Product Change Description

TA-1413(FCC ID:2AJOTTA-1413),TA-1429(FCC ID:22AJOTTA-1429)

is the variant of the initial certified product,

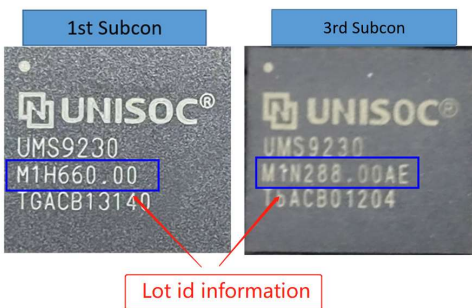
CPU changes: YES, add 3rd substrate for CPU UMS9230, only assembly Site changes, to expand capacity.

1. Hardware reference design unchanged, chip PIN to PIN, Datasheet updated.
2. UMS9230 is a BB chip, add 2nd substrate with assembly Materials change, no other changes
3. UMS9230 is main BB chip, not integrates RF transmitters, memory.
4. From Unisoc side, they are the same series chip and also P2P completely compatible, did not update the block diagrams to distinguish the two chip.
5. They use the same PMU UMP510G
6. They use the same RF Transceiver SR3595D
7. There is no difference between two source about the form, fit, function, quality and reliability.

The chip (1st and 3rd substrates) can be distinguished from Lot ID
